### **Remarks**

This is in response to the Office Action dated April 21, 2005.

FIG. 1

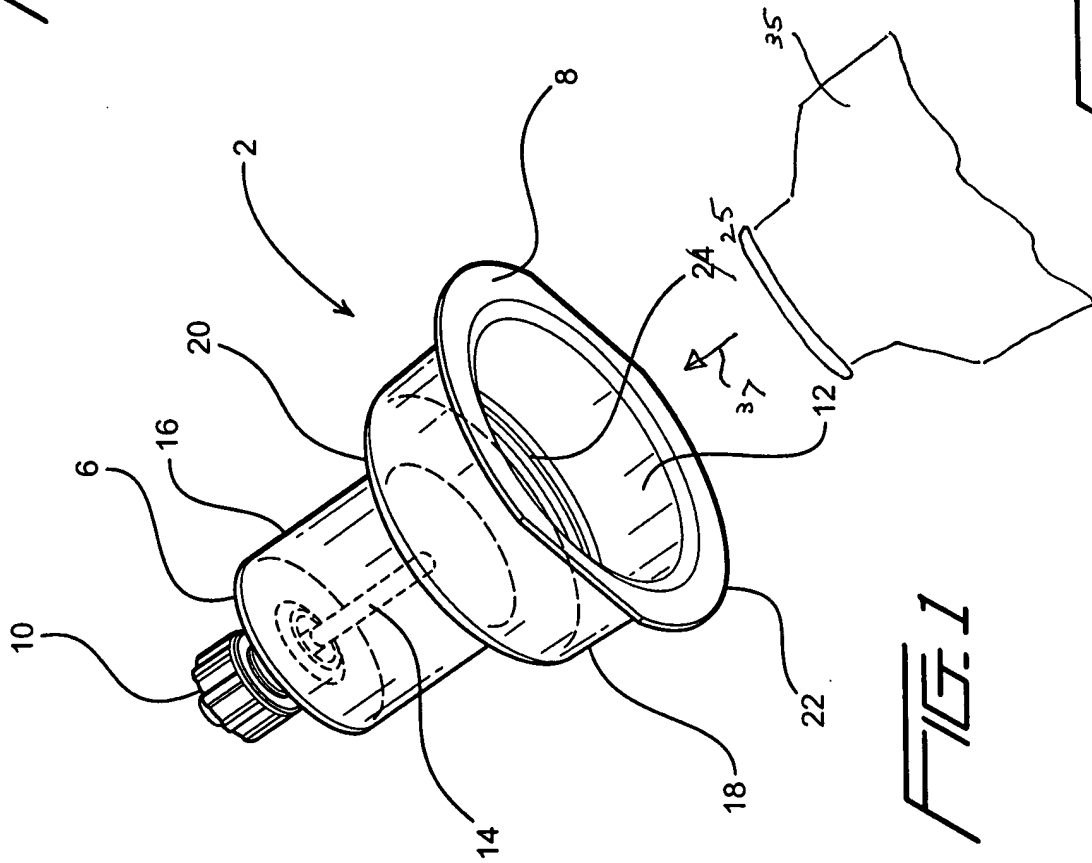
In response to the objection to the drawings, attached please find a "Annotated Sheet Showing Changes" of the amendment to Fig. 3 to correctly identify the distal portion by designation "16". Moreover, Fig. 1 has been amended per shown in red, in order to replace designation "24" with designation "25", as designation "24" was also used to designate the groove shown in Fig. 4. Moreover, Fig. 1 has been amended to show the collection store, in the shape of a blood culture collection bottle 35, that is inserted into the member 2. Appropriate corresponding amendment in the specification has been effected. A "Replacement Sheet" is attached showing the amended changes.
